3rd & Cherry

DESIGN REVIEW BOARD RECOMMENDATION MEETING

April 2, 2019

Project Address: **601 4th Avenue**
SDCI Project #: **3028747**

Elevator Precedent - 66-68 Songhees Road, Victoria

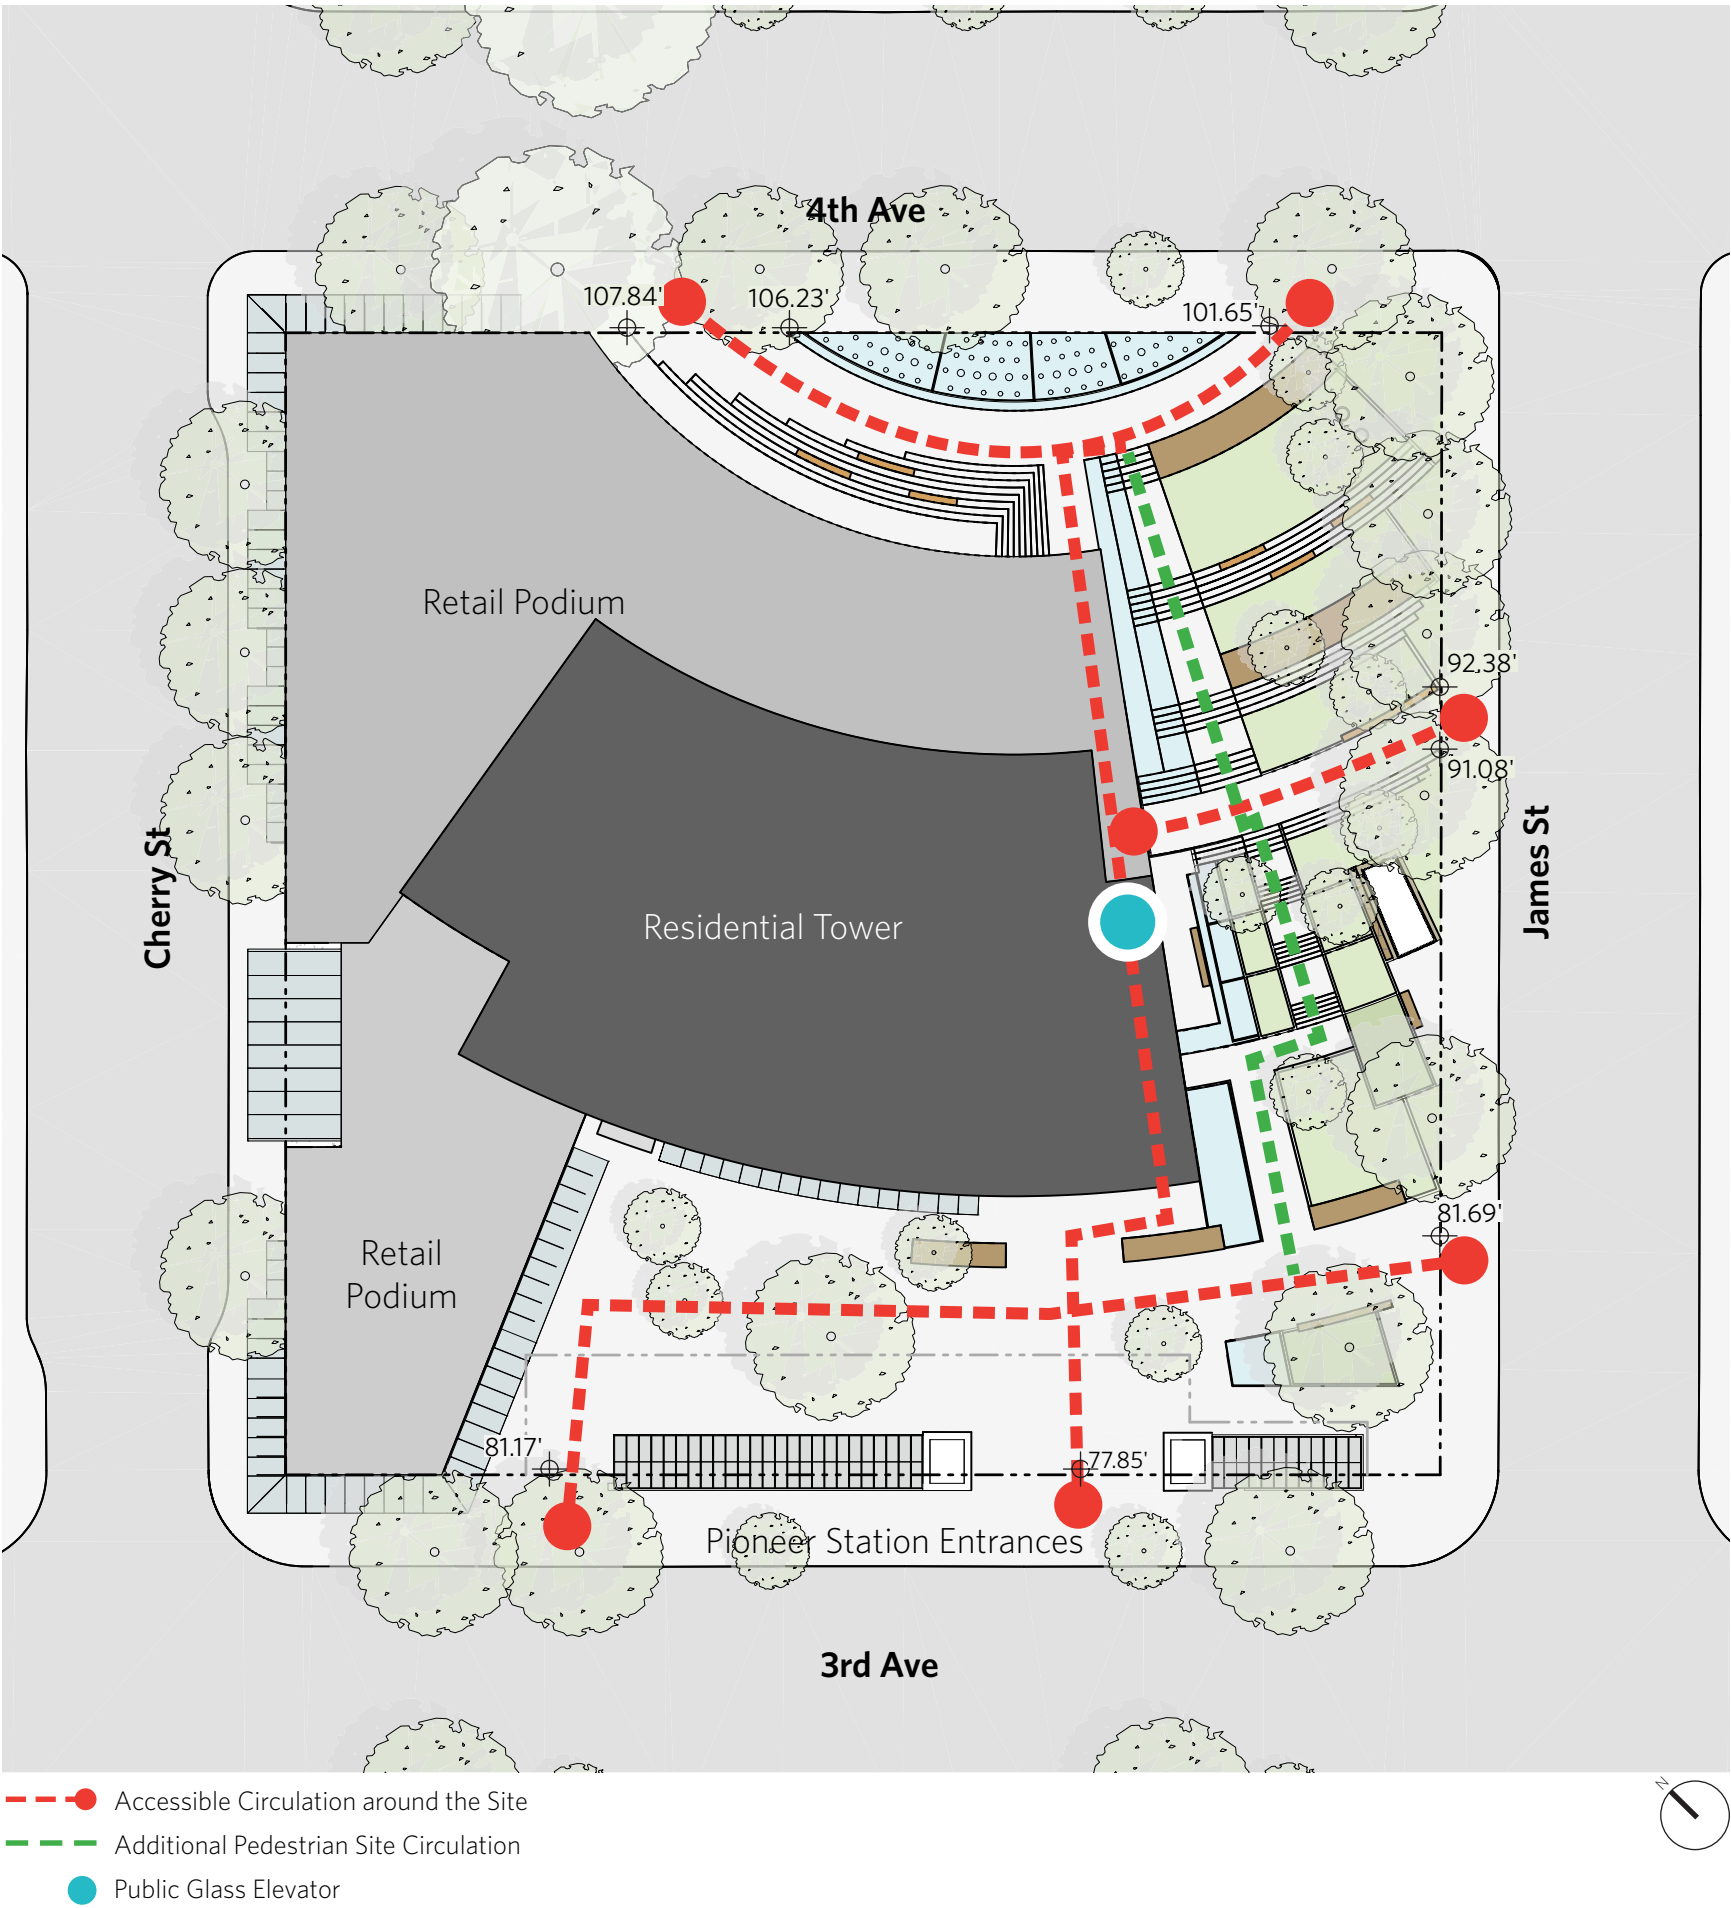
The Board continued to stress the importance of balancing pedestrian connectivity through the space with the sidewalk circulation. Echoing public comment, the Board recommended incorporating accessible routes through the site and supported adding an elevator to allow for a fully accessible route. (B1, C1, D1, D3)

An accessible route is maintained through the steep site with the addition of an elevator.

It has been located adjacent to the building under the building's large soffit to avoid obscuring views through the site, while protecting those using it from the elements. Furthermore, it is offset from the building to indicate it as a public feature.

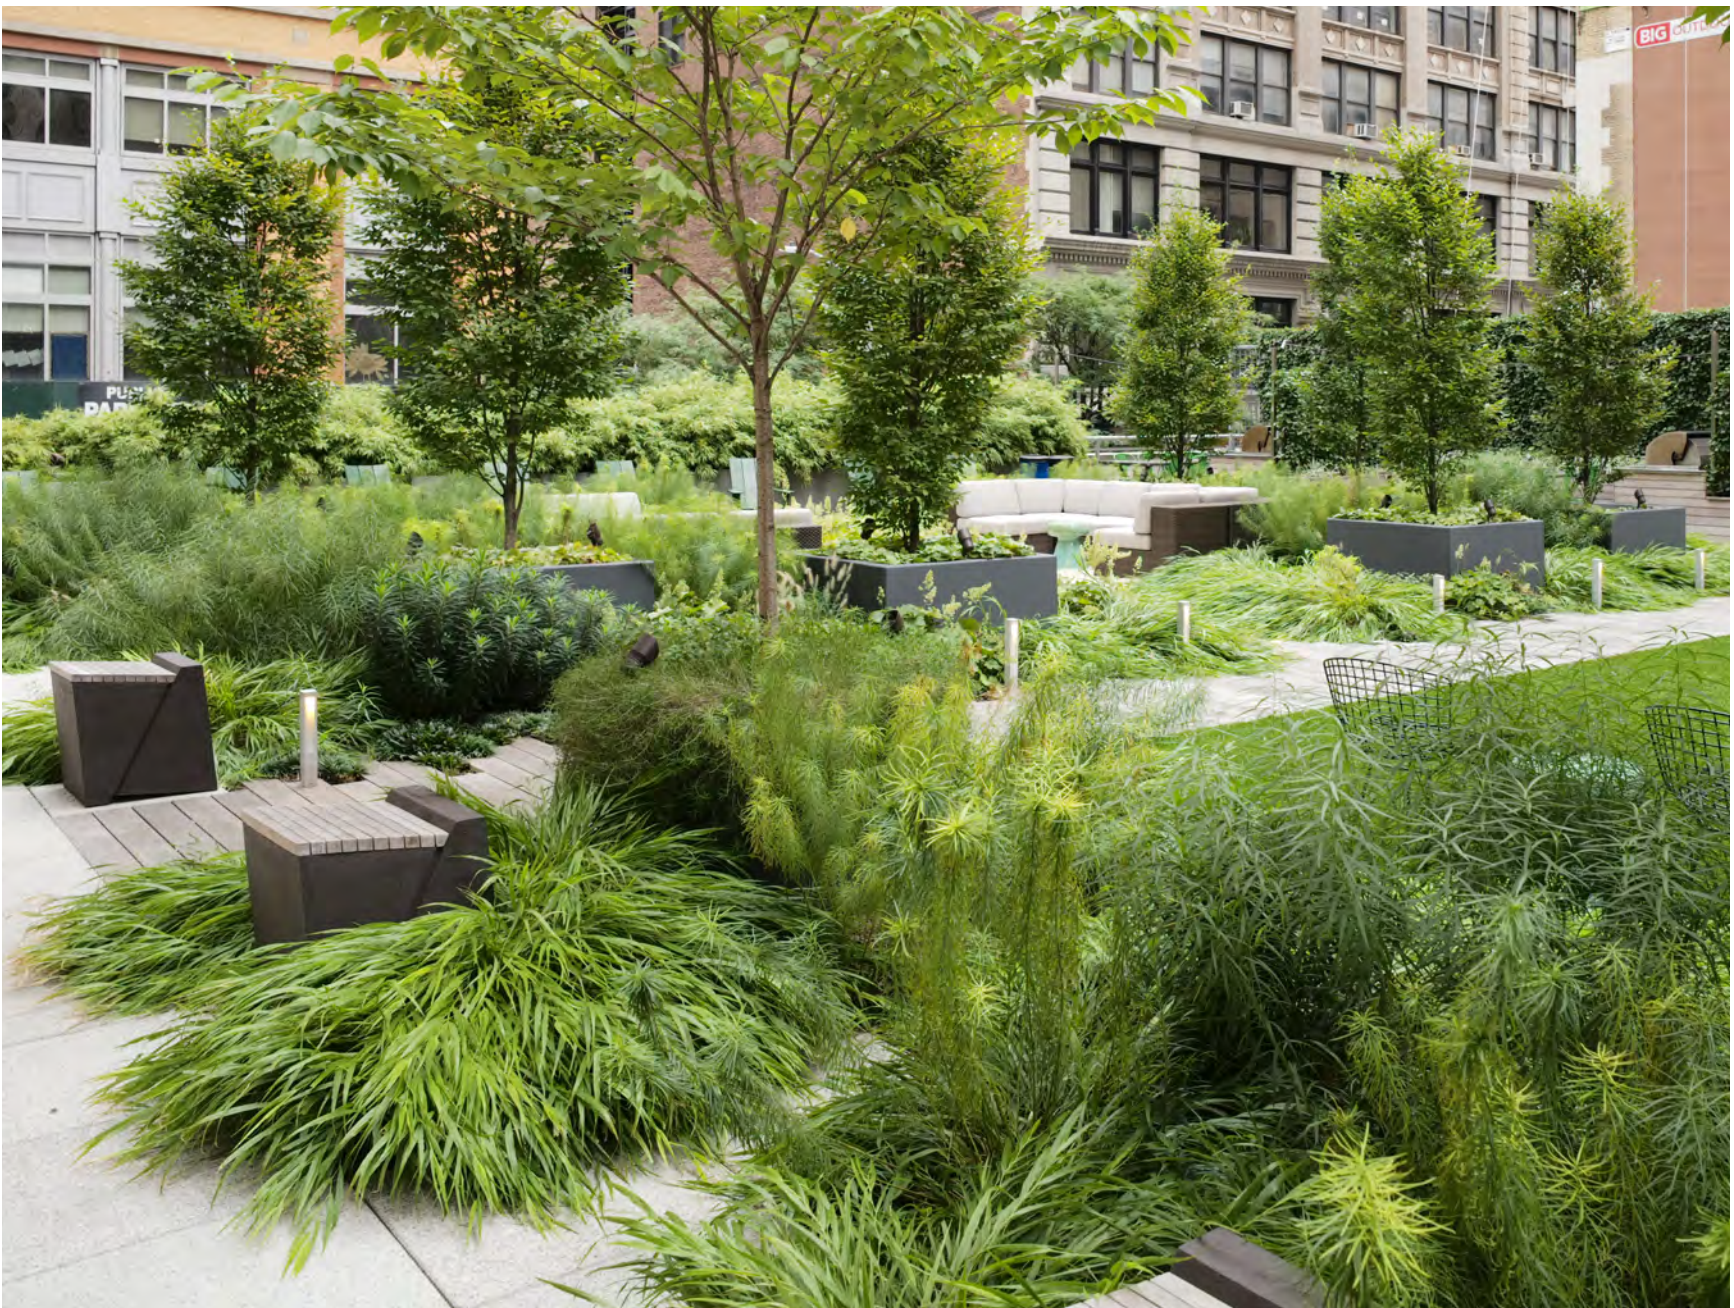
The Board acknowledged public comment related to sustainability and encouraged the applicant to develop sustainability measures into the project. The Board also noted they would consider departures to better achieve sustainability goals. (A1, B4)

Sustainable features integrated within the project include:

- Stormwater retention on various levels
- Garden roofs
- Rooftop urban agriculture (creates opportunities for residents)
